# The Town of Hilton Head Island Regular Design Review Board Meeting

Tuesday, September 28, 2010

PROJECT	Hilton Head Brewing Company	DRB#	DR100036				
DATE	9/28/2010	RECOMMEND APPROVE	<input type="checkbox"/>	RECOMMEND APPROVE W/COND.	<input checked="" type="checkbox"/>	RECOMMEND DENY	<input type="checkbox"/>

SHEET:  
**A-1**

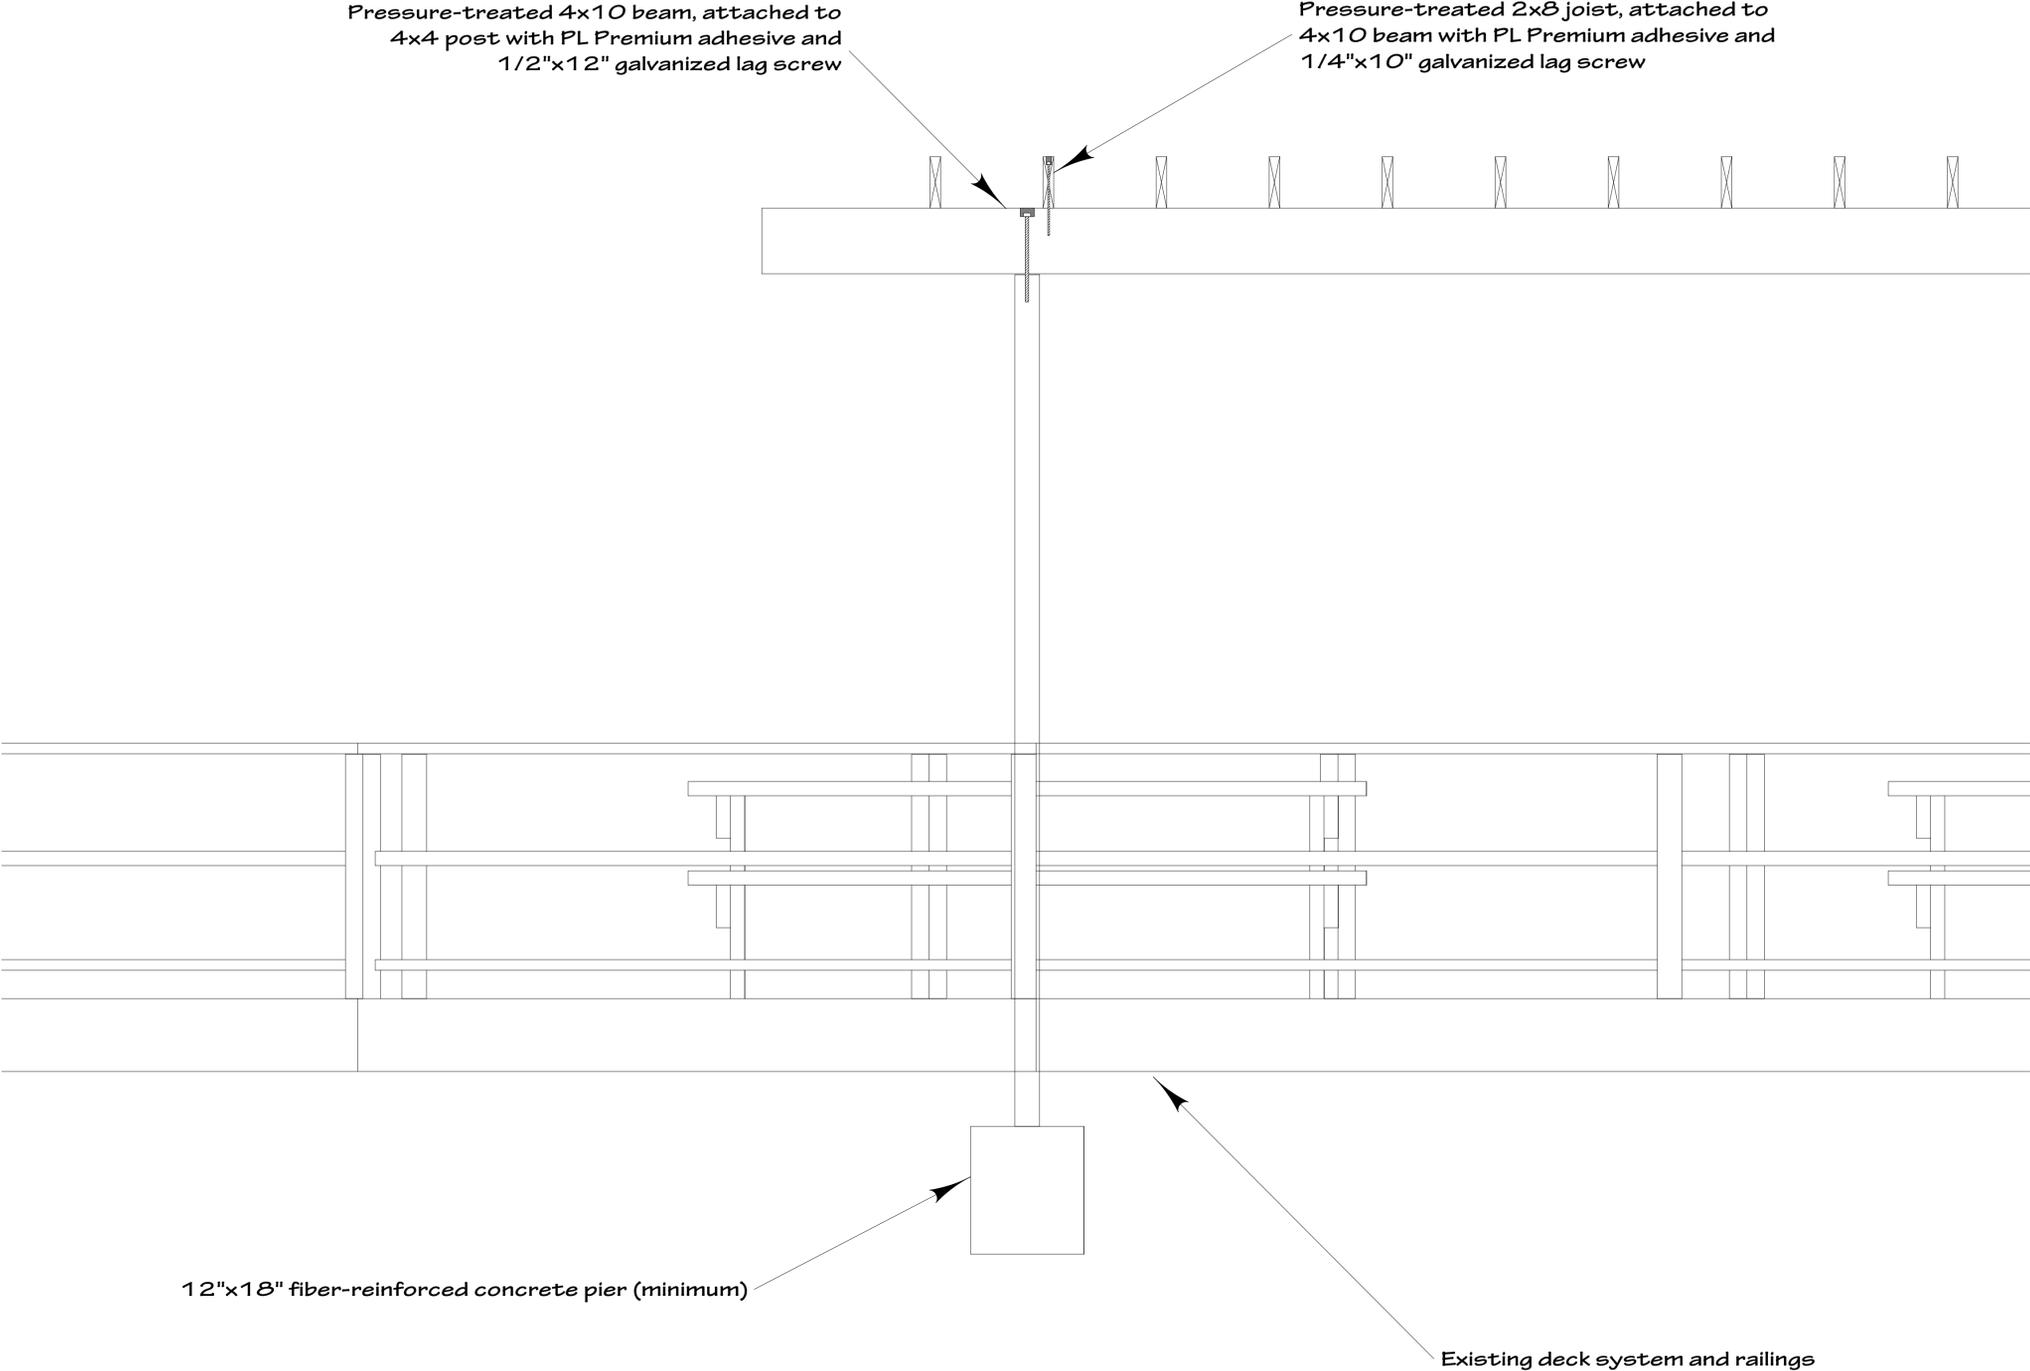
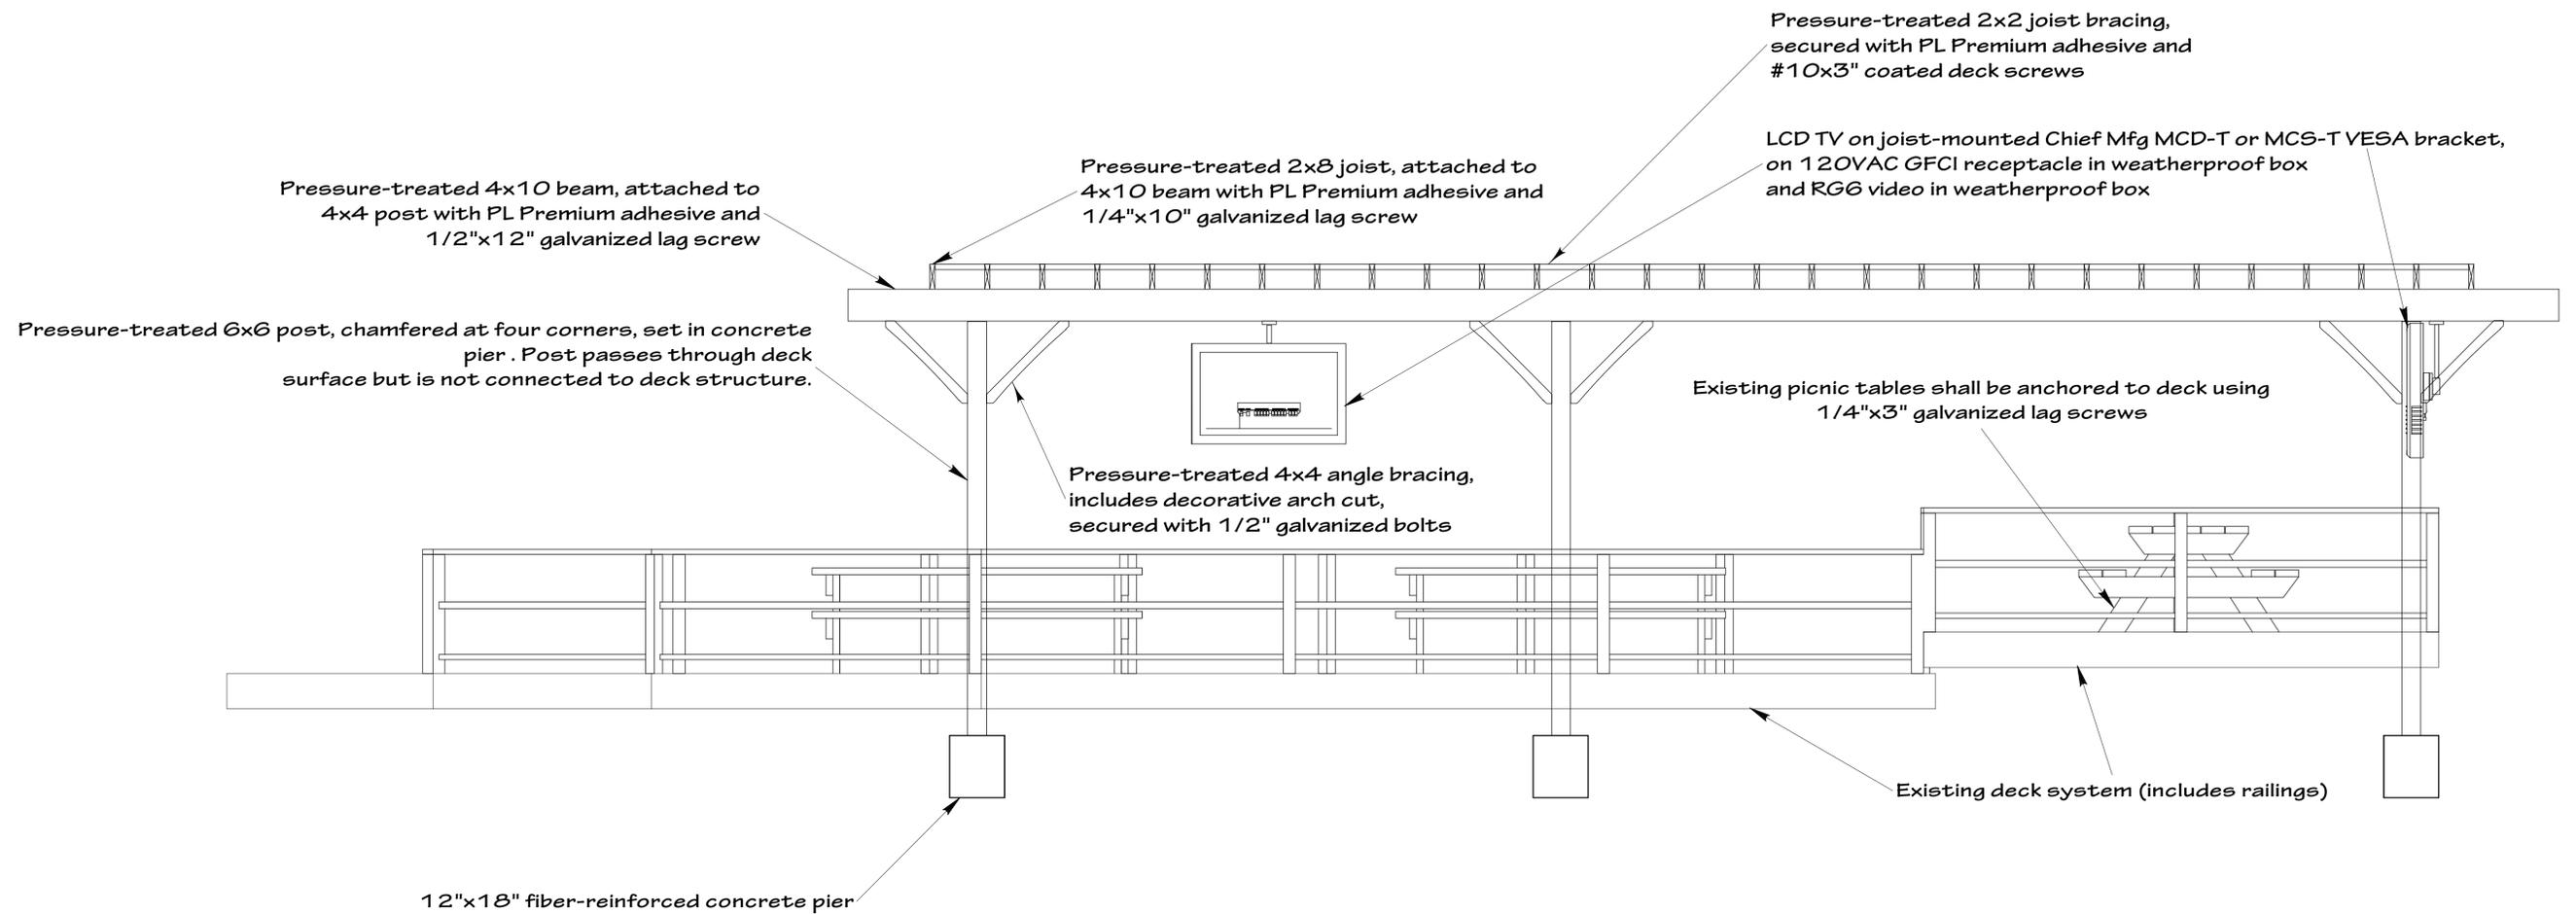
Applicant has increased the size of the posts to 6x6” with associated chamfering, provided an end detail to the horizontal elements, and added a coved knee-brace (some dimensioning to be clarified), per the boards recommendations. The proposed construction is much more successful proportionately than the previous submission.

DESIGN GUIDE/LMO CRITERIA	COMPLIES YES/NO/NA	COMMENTS OR CONDITIONS
An effort has been made to preserve existing trees and under story plants		The edge of the pergola must not be close enough to the large pine at the corner of the existing deck to be hit by the pine when it sways in the wind. Pergola supports must be at least 6 feet from the base of the pine.
Supplemental and replacement trees meet LMO requirements for size, species and number		
Wetlands if present are avoided and the required buffers are maintained		
Sand dunes if present are not disturbed

- South Elevation -

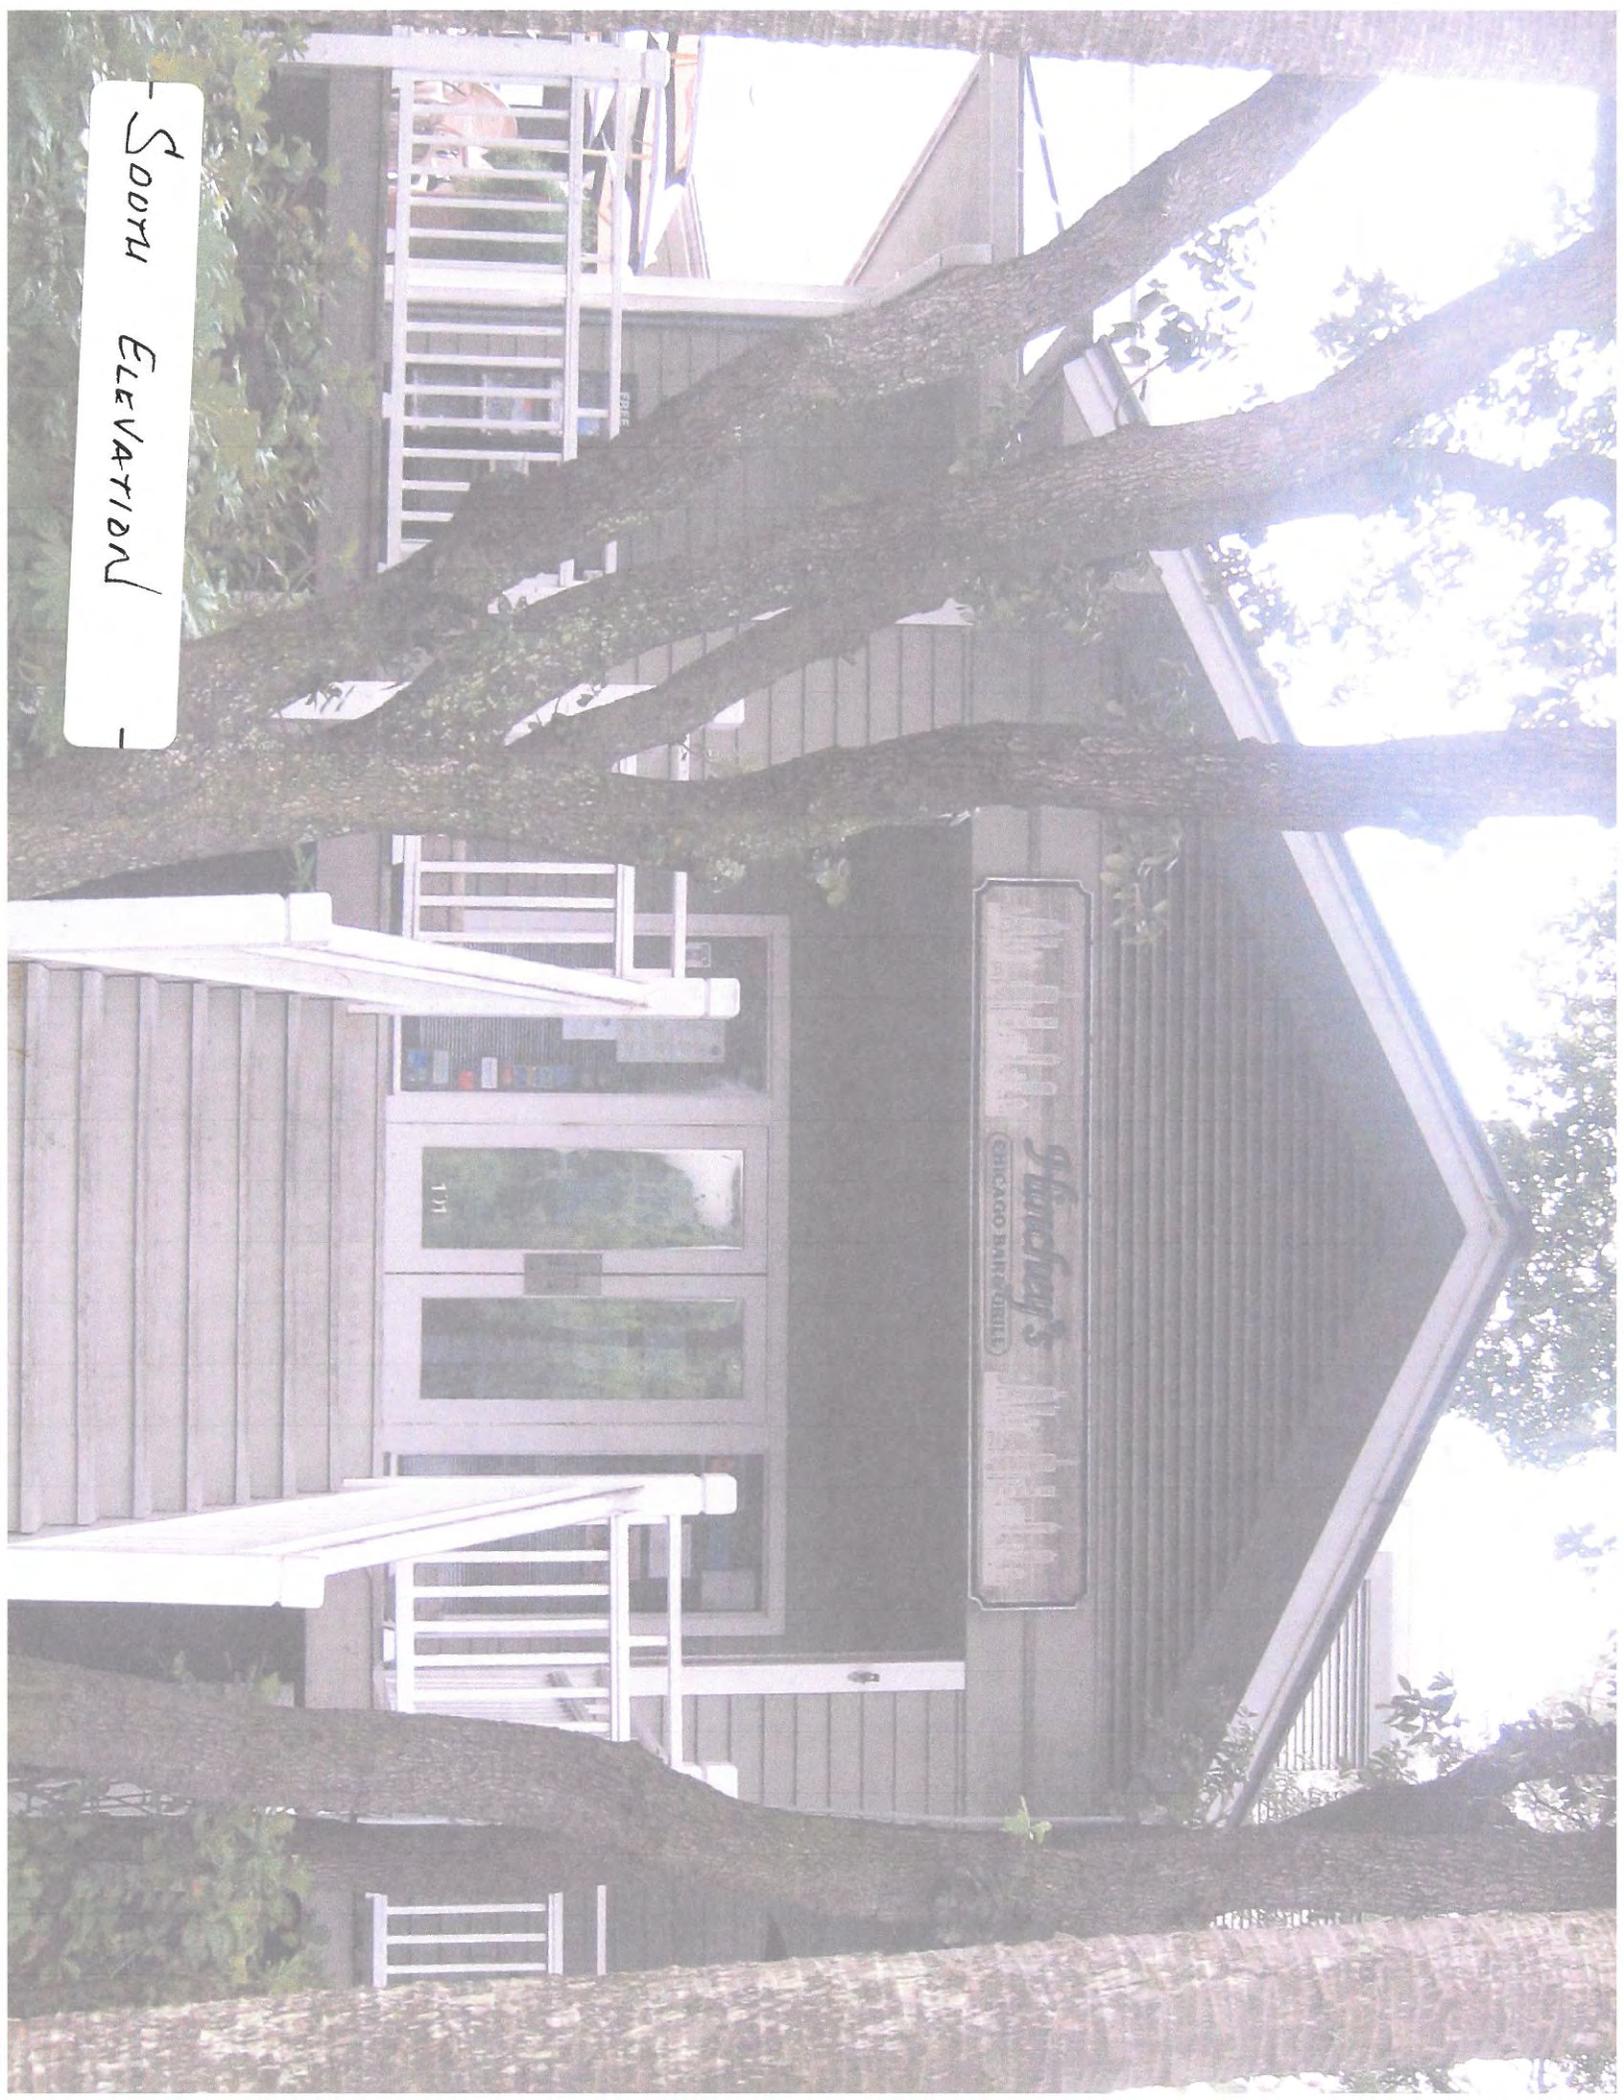
Applicant has updated the South Elevation to accurately reflect 18'-0" sliders in place of the existing storefront. All other elements (columns, specifically) remain unchanged and are better reflected on the drawing
